Re: PETITION NO. 1580 – CT Solar PDF, LLC petition for a declaratory ruling, pursuant to Connecticut General Statutes §4-176 and §16-50k, for the proposed construction, maintenance and operation of a 1.45-megawatt AC solar photovoltaic electric generating facility located at two parcels on the Medtronic campus at 86 Quinnipiac Avenue and 195 McDermott Road, North Haven, Connecticut, and associated electrical interconnection.

**RESPONSES OF CT SOLAR PDF LLC TO CONNECTICUT SITING COUNCIL
INTERROGATORIES**

EXHIBIT A: SITE BOUNDARY MAP

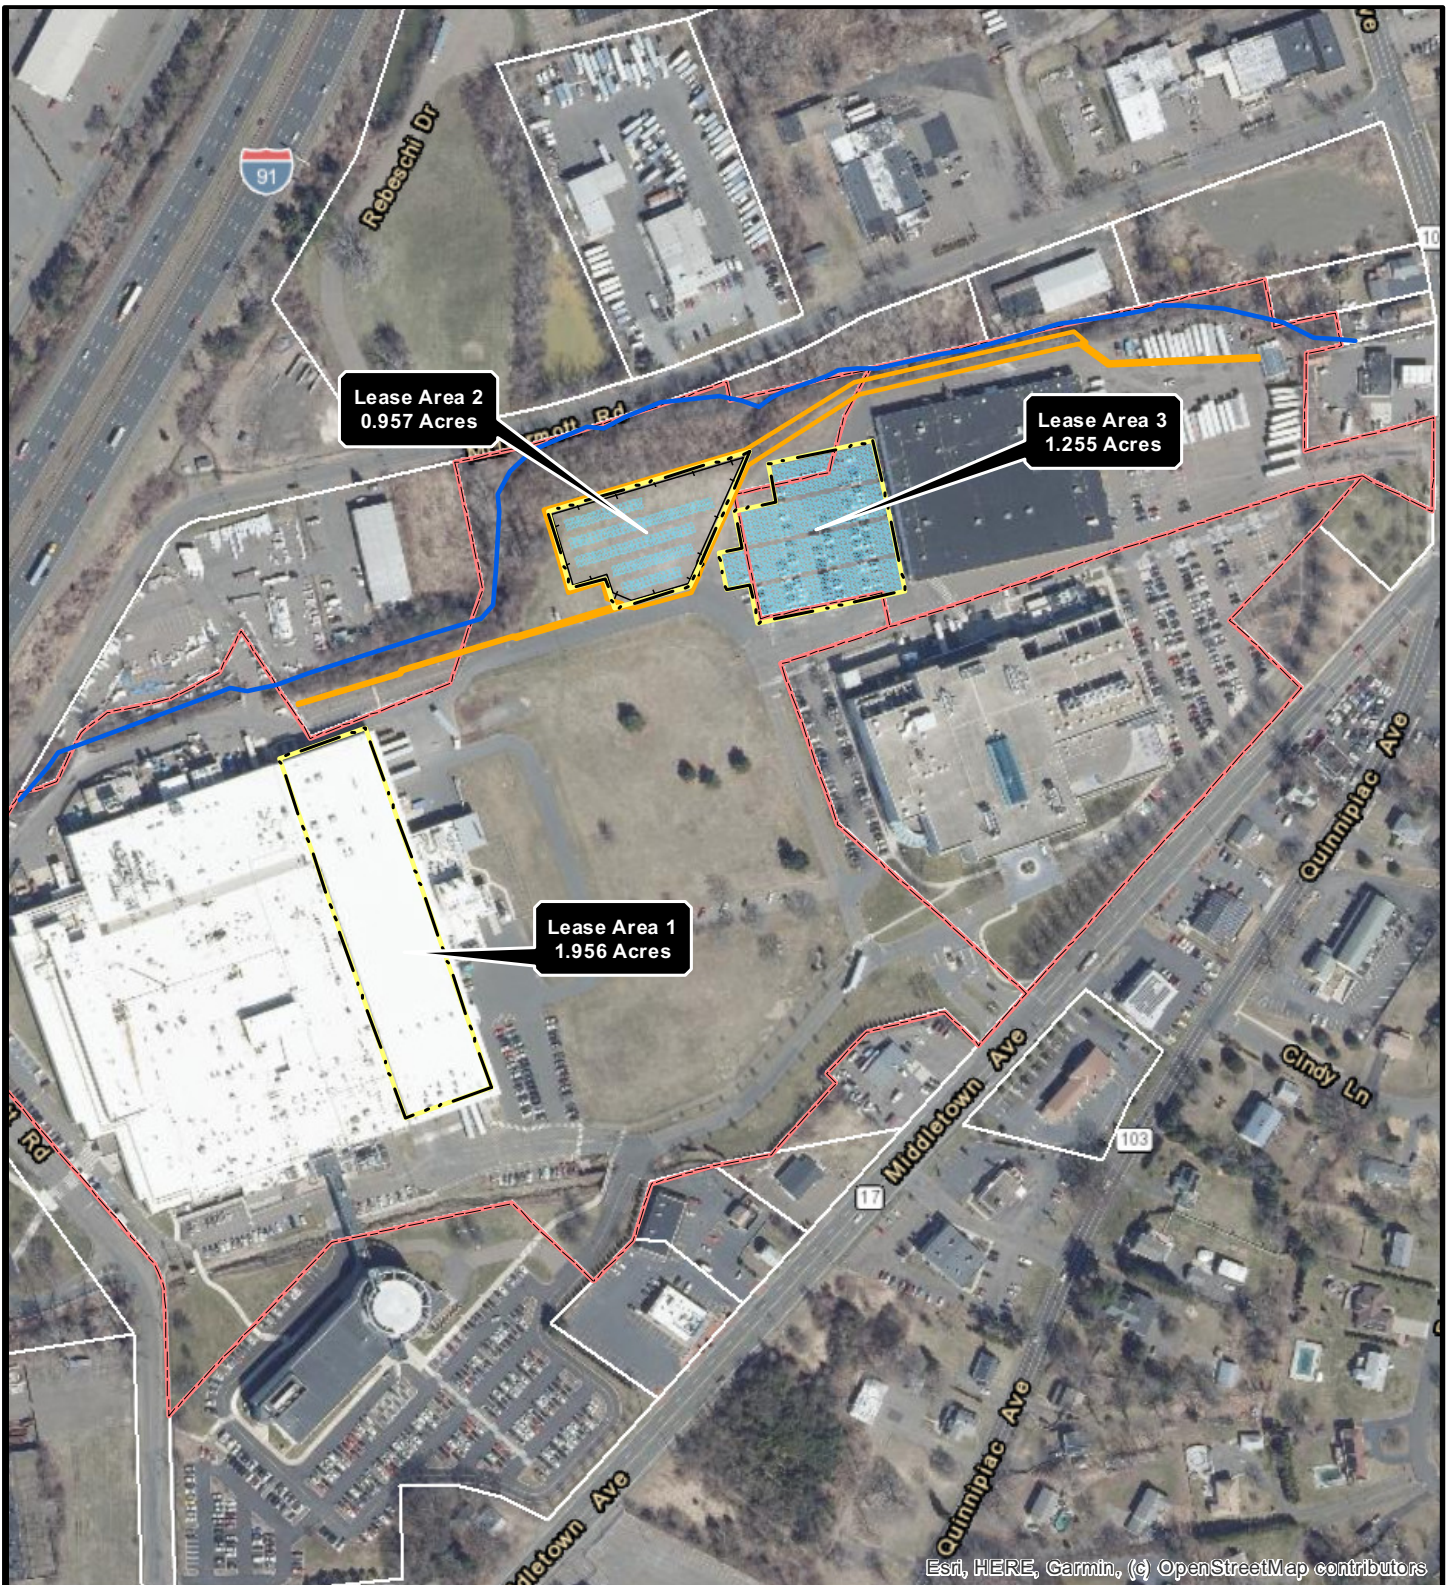
8. **Submit a map clearly depicting the boundaries of the solar facility site and the boundaries of the host parcel(s). Under Regulations of Connecticut State Agencies (RCSA) §16-50j-2a(29), “Site” means a contiguous parcel of property with specified boundaries, including, but not limited to, the leased area, right-of-way, access and**

easements on which a facility and associated equipment is located, shall be located or is proposed to be located.

RESPONSE: See Exhibit A.

EXHIBIT B: PROPOSED CANOPY DESIGN DRAWING

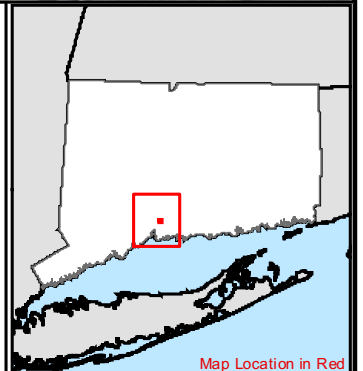
19. **For the parking canopy array;**
- a. **provide a drawing that provides detail of the proposed canopy design.**
 - b. **submit a photograph of the similar canopy design.**
 - c. **are the solar panels attached to a steel canopy roof? If so, is the steel roof pitched for sheet drainage or is runoff collected and directed to drainpipes?**
 - d. **To what depth would the canopy support columns be installed?**

- a. See Exhibit B.
- b. See Exhibit C.
- c. No, the solar panels will not be attached to a steel canopy roof.
- d. 12 feet.

Figure 1. Photo Locations
CT SOLAR PDF LLC - Nokomis Energy
Medtronic Robotics
North Haven, CT, 06473
New Haven County

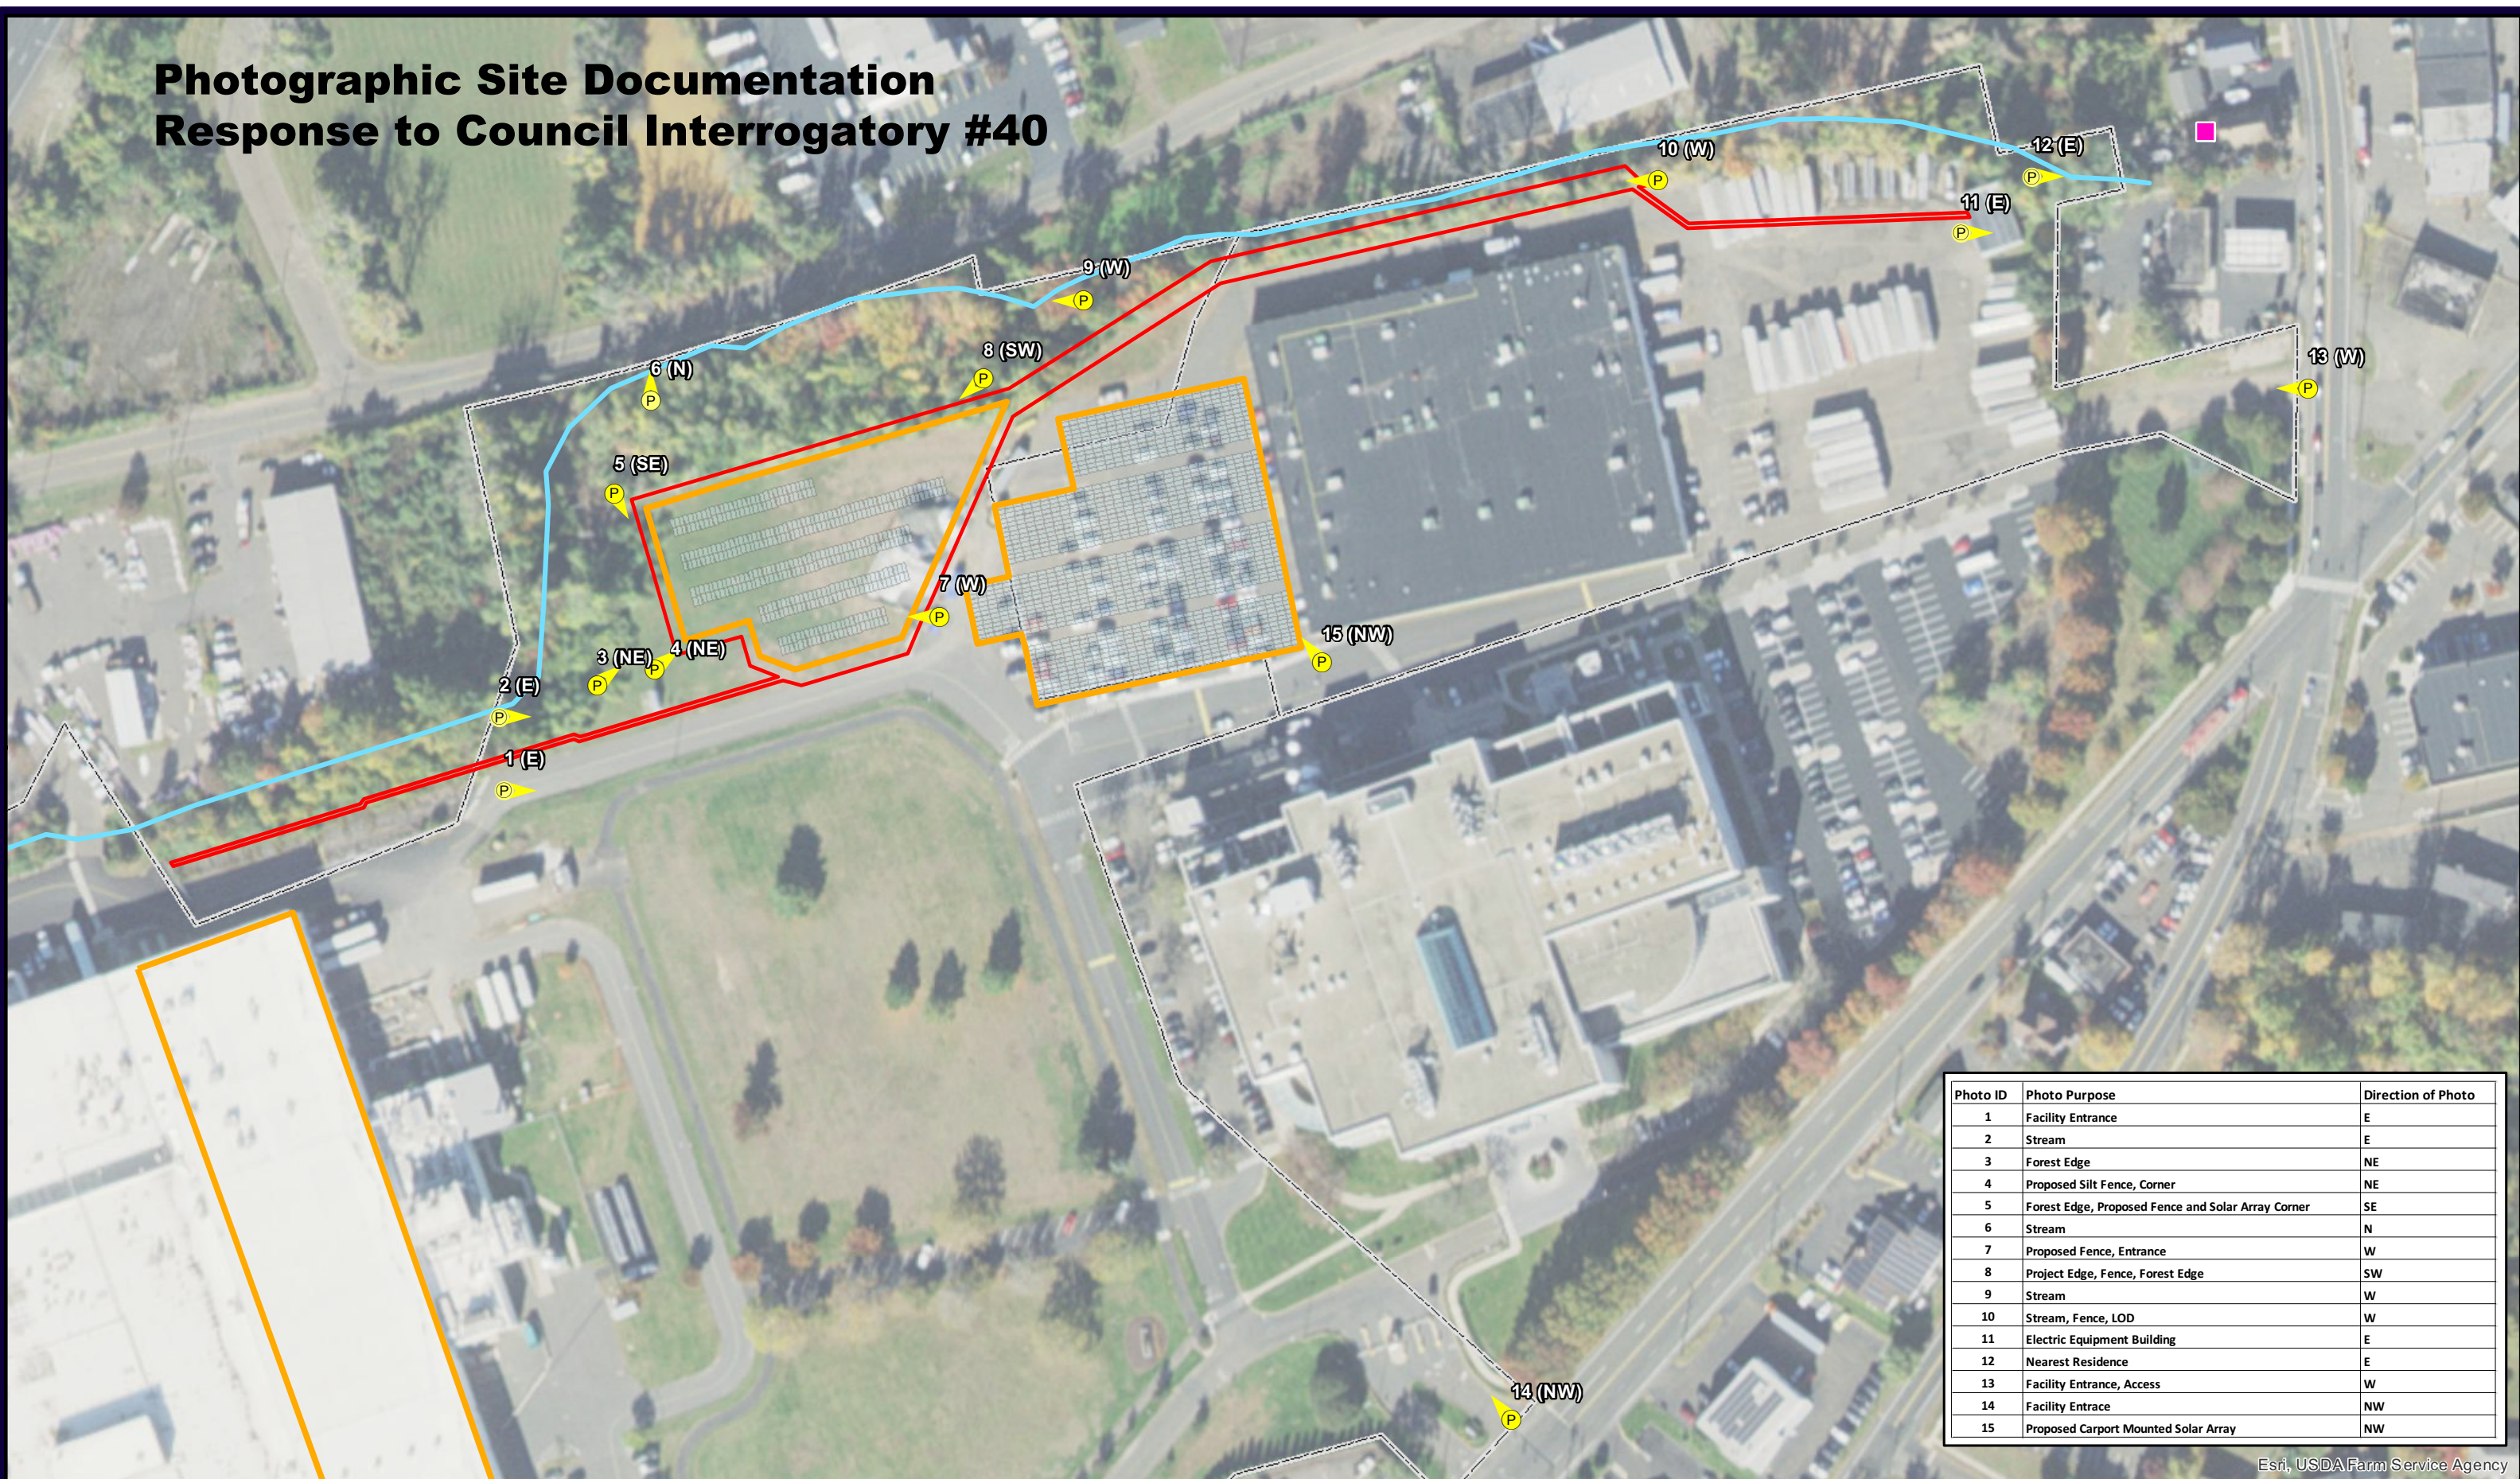
40. Submit photographic site documentation with notations linked to the site plans or a detailed aerial image that identify locations of site-specific and representative site features. The submission should include photographs of the site from public road(s) or publicly accessible area(s) as well as Site-specific locations depicting site features including, but not necessarily limited to, the following locations as applicable:

A photolog graphic must accompany the submission, using a site plan or a detailed aerial image, depicting each numbered photograph for reference. For each photo, indicate the photo location number and viewpoint direction, and clearly identify the locations of site-specific and representative site features show (e.g., physical staking/flagging or other means of marking the subject area).

RESPONSE: See Exhibit D.
